Product(s) Affected:

Discovery Plate (DPL) Loaded Strength Line and Discovery Selectorized (DSL) Strength Line.

Diagram 1

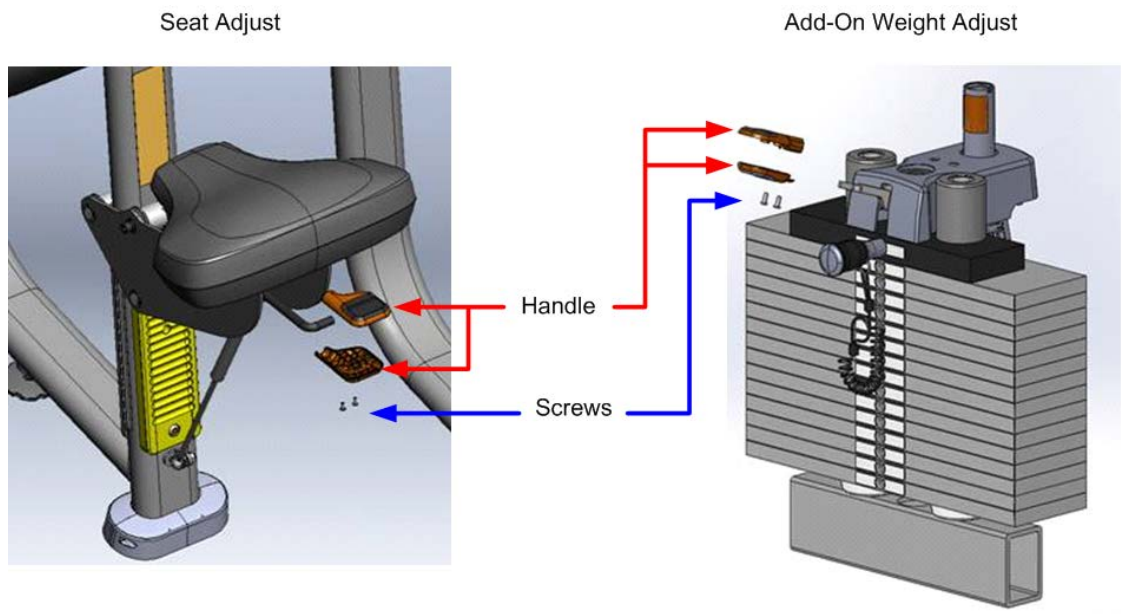
The screws that secure the handles to the add-on weight lever and seat adjust lever may back out causing the handles to become loose or fall off the lever. **See Diagram 1.**

If the described symptoms occur, apply blue Loctite 243™ to the threads of the screws (PPP0000TECN004010) that secure the handles to the lever. Install the screws and fully tighten.
